UNITED STATES PATENT AND TRADEMARK OFFICE

Office Action Summary	Application No. 10/777,572	Applicant(s) BURTON, DAVID	
	Examiner Shumaya B. Ali	Art Unit 3771

DETAILED ACTION

Figure 2

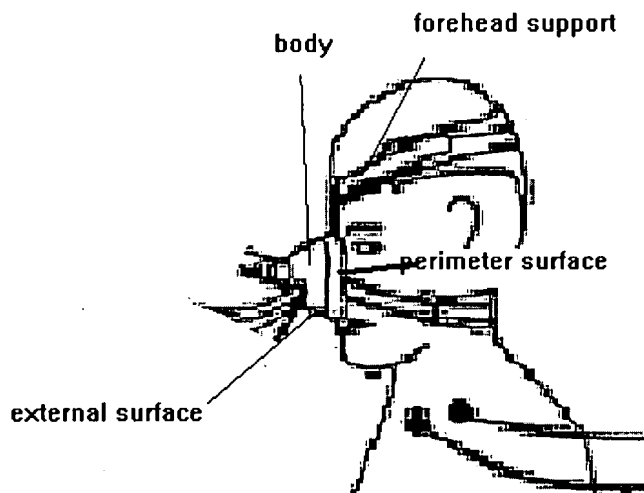
As to claim 8, Miles discloses a gas delivery system comprising a mask (see labeled fig.2, attachment below) having at least one physiological sensor (col.4, lines 55-60) connected (col.4, lines 43-45) thereto; a gas delivery device (fig.2,1) having an adjustable gas delivery setting (gas delivery adjustment is possible via 12), and a processor (fig.2, 12) in communication with the gas delivery device and the sensor, the processor is adapted to determine the existence of a sleep disorder and to adjust the gas delivery setting based thereon (see col.5, lines 26 and 27, lines 48-50, and col.6, lines 17-24).

As to claim 14, Miles discloses a gas delivery system comprising a mask (see labeled fig.2 attachment below) having at least one EEG sensor (col.4, lines 55-60) connected thereto, a gas delivery device (fig.2,1) having an adjustable gas delivery setting (delivery is adjusted via a processor 12); a processor (fig.2, 12) is communication with the gas delivery device and the

As to claim 24, Miles discloses an apparatus comprising a mask (see fig.2 attachment below) having a body position sensor (see col.4, lines 55-60) attached thereto (see col.4, lines 33-37), a processor (fig.2, 12) in communication with the sensor and adapted to determine body position from the body position sensor's output (see col.5 lines 20-68, and col.6, lines 1-30).

As to claim 31, Miles discloses a gas delivery system comprising a gas mask (see fig.2 attachment below) adapted to fit on a patient, a gas delivery device (fig.2,1) having an adjustable gas delivery (via processor 12, see fig.2), and a processor (fig.2,12) in communication with the gas delivery device (see fig.2) and a cardiac pacemaker (processor inherently communicate with a pacemaker via heart rate sensor, see col.6, lines 55-60), the processor

As to claims 1, Miles discloses a mask assembly (3,26) comprising a body (see fig.2, attachment below) having an internal surface (see fig.2, mask inherently have external and internal surface), an external surface (see fig.2, attachment below), and a perimeter surface (see fig.2 attachment below); and a forehead support (see fig.2 attachment below) connected to the body. Miles further discloses EEG sensor (see col.4, lines 55-59). Miles however lacks the forehead support having an EEG sensor (see col.4, lines 44-45; lines 55-59). However, Genger teaches a forehead support bar with sensor that reads brain activity (see fig.1, 9/10/11; see col.1, lines 20-22). Applicant's EEG sensor also detects brain activity. Therefore, it would have been obvious to one of ordinary skill in the art at the time the invention was made to modify Miles to

As to claim 6, Miles discloses a strap extending from the mask (see labeled fig.2 attachment below) and physiological sensors (see col.4. lines 33-35, lines 44-45; lines 55-59; col.5 lines 615, and col.7 lines 37-51), however, lacks said sensor is located on the strap. However, Brown teaches physiological sensors can be located on the strap (see fig.1f, 33). Therefore, it would have been obvious to one of ordinary skill in the art at the time the invention was made to modify Miles to change the location of the physiological sensor because it is known in the art as taught by Brown.
